SUBMITTAL IDENTIFICATION SHEET

WEBSTER UNIVERSITY ISB	
PROJECT NAME	
8274 BIG BEND BLVD	
ADDRESS	
NUMBER	
WEBSTER UNIVERSITY	
OWNER	
CANNON DESIGN	
ARCHITECT / ENGINEER	
DEVIN D GATES	
SUBMITTED BY	
123553-001 REV 2	
CONTRACTOR / CM SUBMITTAL NO.	CANNON DESIGN SUBMITTAL NO.
	123553
DRAWING / DETAIL REFERENCE	SPECIFICATION SECTION / PARAGRAPH
MANUFACTURER / SUPPLIER	ITEM / PRODUCT ID
REQUIRED DATE	PRIORITY
	CRITICAL

DATE: 1/25/2017
JOB: 04437A, B, C, D
RE: Webster University
Webster Groves, MO

Hebgo Bracket

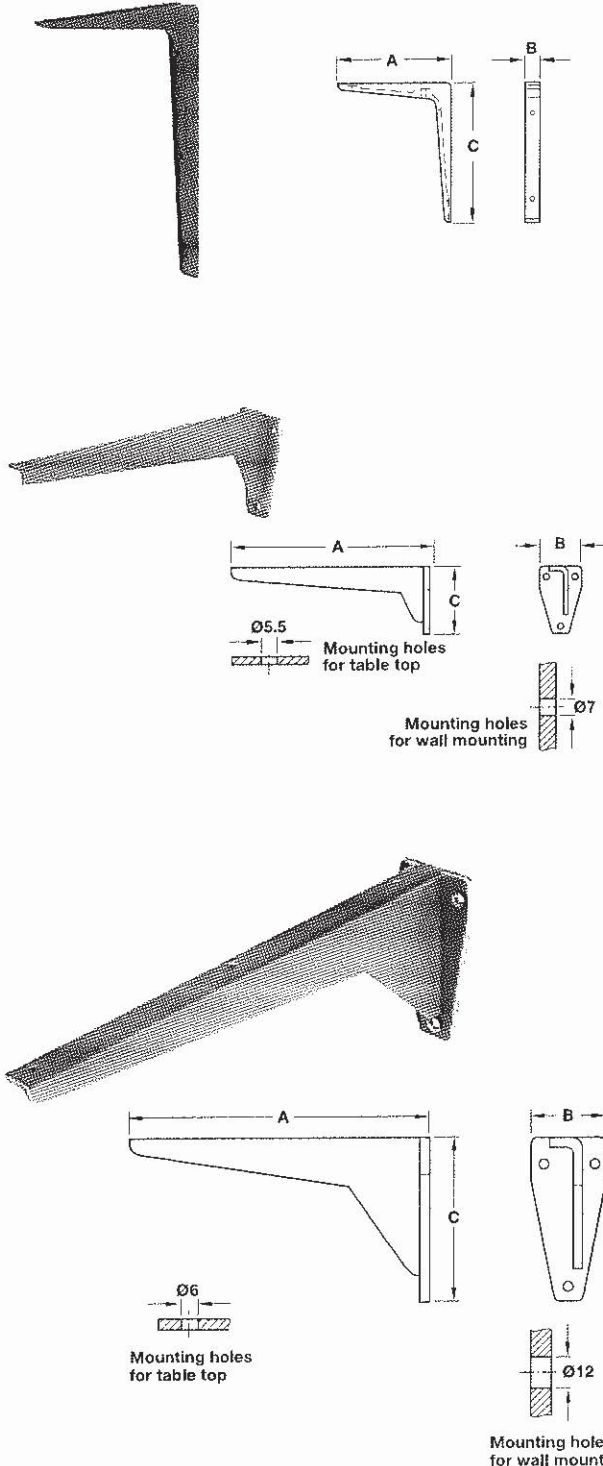
SELECTION APPROVED PROVIDED IT MEETS THE PERFORMANCE REQUIREMENTS FOR COUNTERTOP STABILITY, LOADING, ETC...

CONTRACTOR TO CONFIRM BRACKET MEETS PERFORMANCE REQUIREMENTS
